PCN25-3—  
KSA0M912 LFT Design Change

Revision	Date	Description	Author
A	February 14th, 2025	Change to Anti Particle Design KSA0M912 LFT	M.Schnelle

KSA MKII (without anti-particle design)

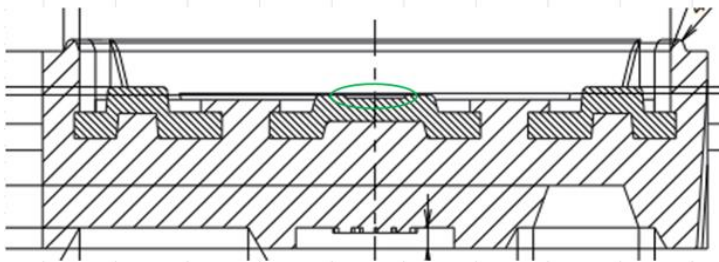
The design of the central fixed contact will be updated to align with the KSC standard, reducing the risk of intermittent lack of the electrical contact.

An anti-particle design will be implemented to create a circular electrical contact, ensuring reliable connectivity even in cases of contamination on the contact surface. This design features multiple electrical contact points, as opposed to a single flat surface, significantly decreasing the likelihood of electrical contact failure.
